ANN ARBOR HISTORIC DISTRICT COMMISSION

Staff Report

ADDRESS: 514 Lawrence Street, Application Number HDC13-050

APPLICATION: The applicant seeks HDC approval to: install a wood gate with an electric opener across the driveway; pave the driveway with asphalt; and install a turnaround area in front of the garage using permeable pavers.

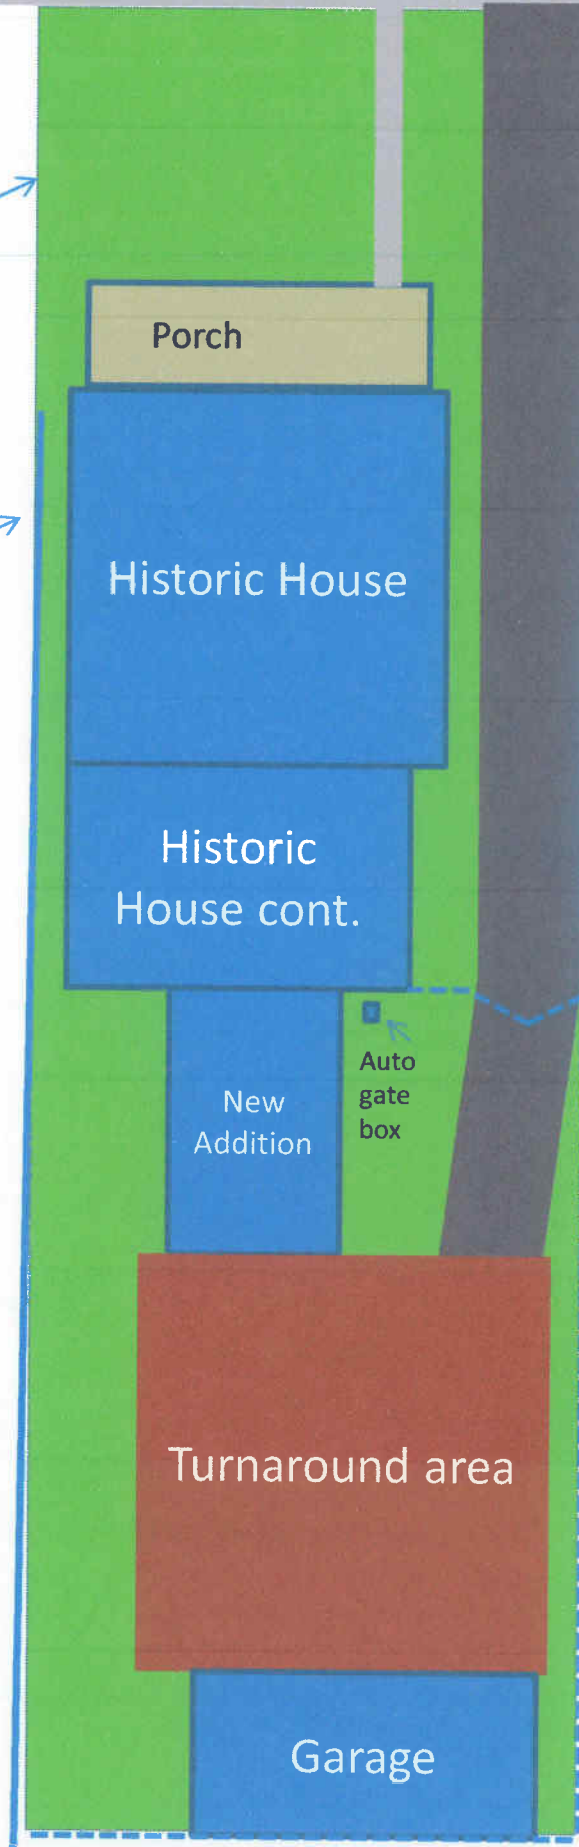
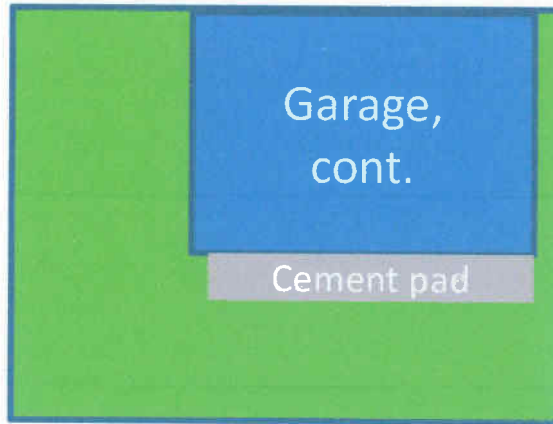
3. The 9' wide driveway maintains a landscape strip between the house and drive, which is appropriate. The 30' x 30' turnaround area has decorative permeable pavers and can double as a patio. This area is shaded by a large elm tree along the east property line, and the permeable pavers are appropriate since the turnaround area is within the drip line of the tree. The turnaround area is quite large, but certainly more contained than the current gravel backyard (which used to be entirely a parking lot), and the use of decorative pavers will help the area feel like an extension of the garden that surrounds it.

4. Staff recommends approval of the application. The turnaround area is appropriate for this backyard on this block, the power gate is unobtrusive and will help eliminate pedestrian cut-throughs on the property, and the driveway paving is an appropriate width and maintains a landscape strip between the pavement and the house. The proposed work is generally compatible in exterior design, arrangement, texture, material and relationship to the rest of the building and the surrounding neighborhood and meets the *Ann Arbor Historic District Guidelines* for residential decks and patios and landscape features, and *The Secretary of the Interior's Standards for Rehabilitation*, in particular standards 2 and 10, and the guidelines for building site.
